## **WORK SESSION AGENDA**

#### **REGULAR MEETING AGENDA**

Session 13-13, a Regular Meeting of the Homer Advisory Planning Commission was called to order by Chair Venuti at 6:30 p.m. on September 18, 2013 at the City Hall Cowles Council Chambers located at 491 E. Pioneer Avenue, Homer, Alaska.

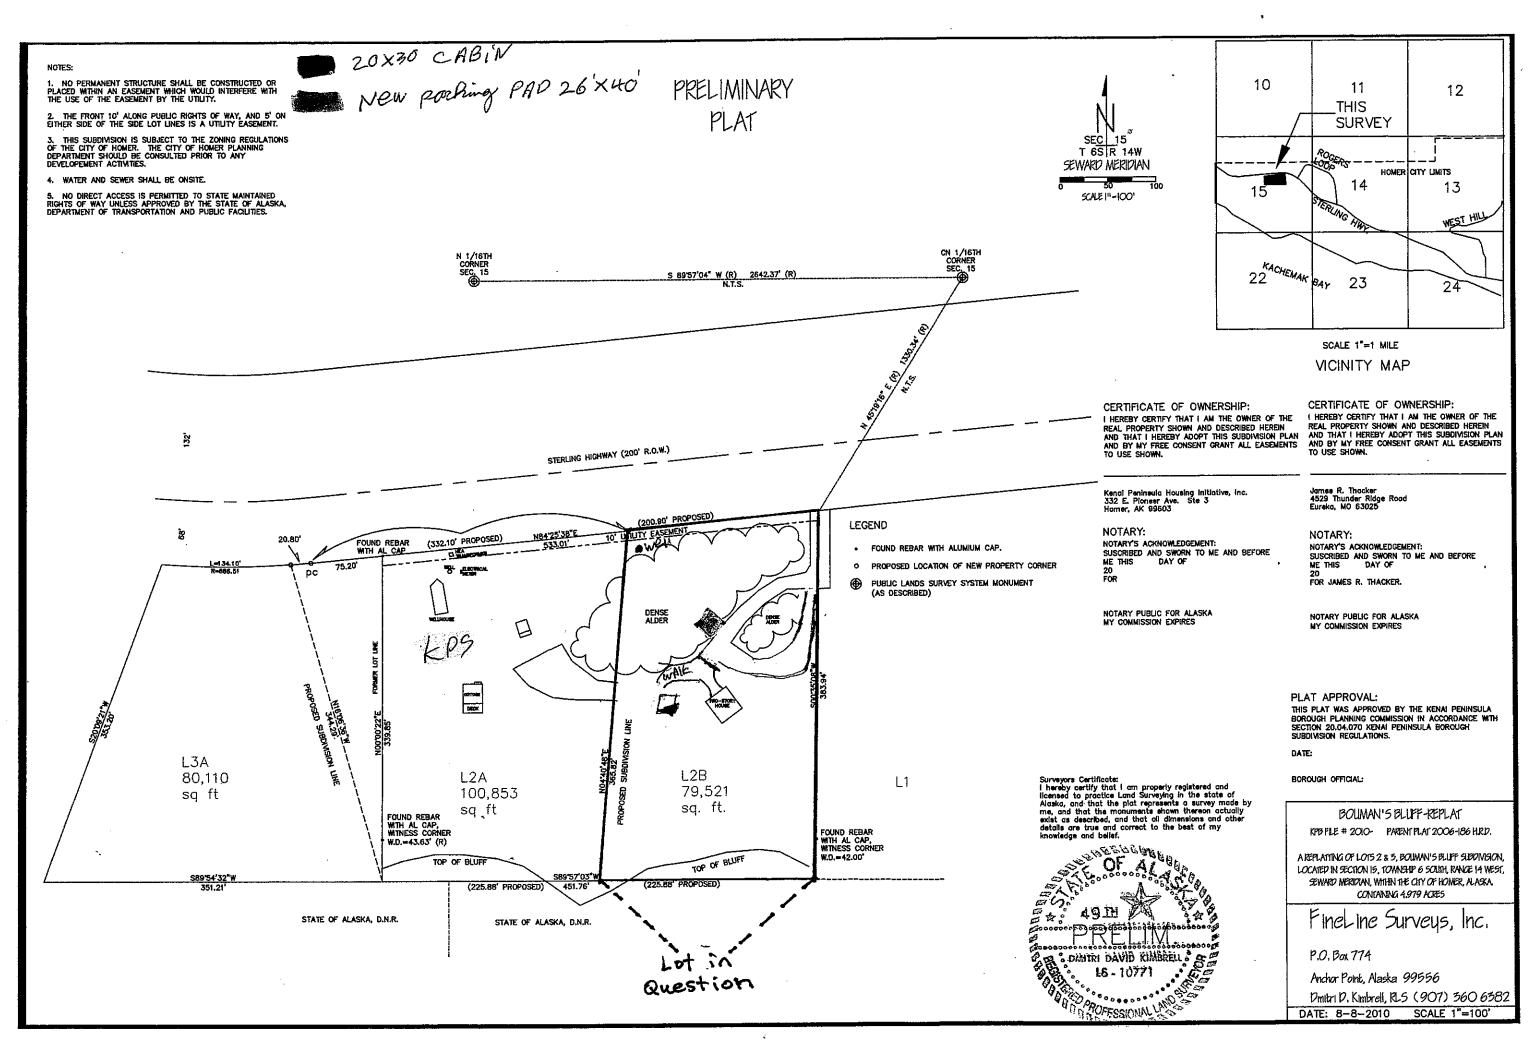
PUBLIC WORKS COMMENTS: No comment. FIRE DEPARTMENT COMMENTS: No comment.

STAFF COMMENTS/RECOMMENDATIONS: Planning Commission approve CUP 13-09 with one condition:

Prior to issuance of a Zoning Permit to construct an additional dwelling, the applicant to provide documentation that the: "The lot is served by public water supply approved by the State Department of Environmental conservation;" per HCC 21.12.040(a)(s)(i) Rural Residential Dimensional Requirements.

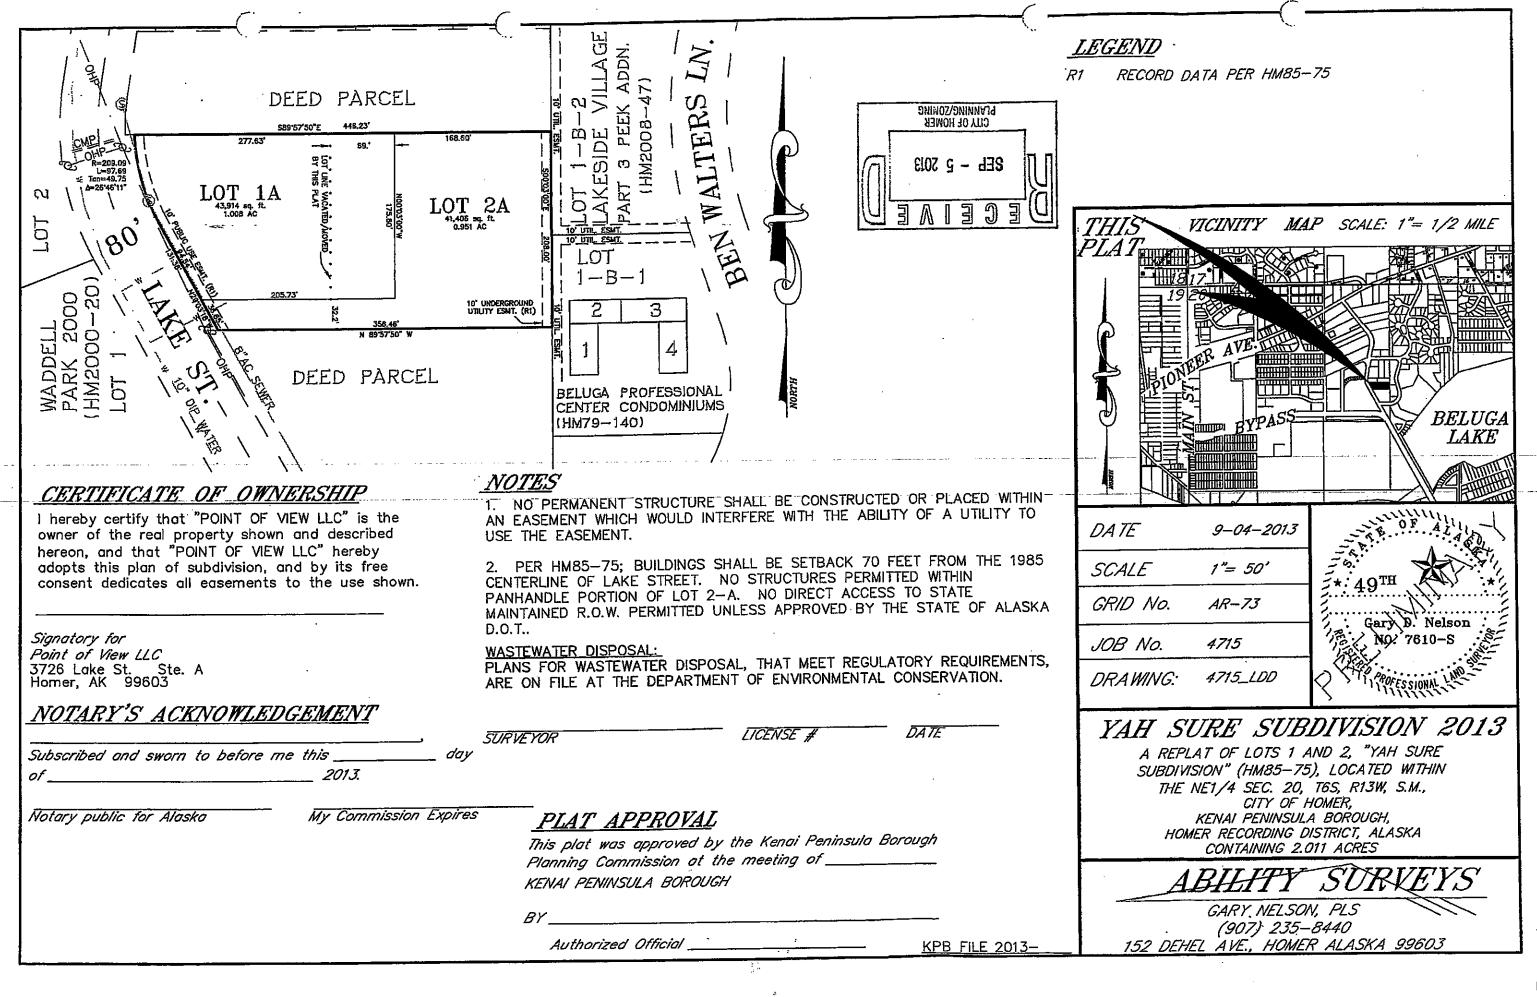
Staff Response: The plat does not meet these requirements. Utilities are already installed in this subdivision and display on this plat in not necessary.

**PUBLIC WORKS COMMENTS:** Dedicate the required 15' utility easement along Lake Street.

Planning Commission recommend approval of the preliminary plat with the following comments:

- 1. Dedicate the required 15' utility easement along Lake Street per HCC 22.10.051(a).
- 2. Add a plat note stating development of these lots is subject to the City of Homer zoning regulations.
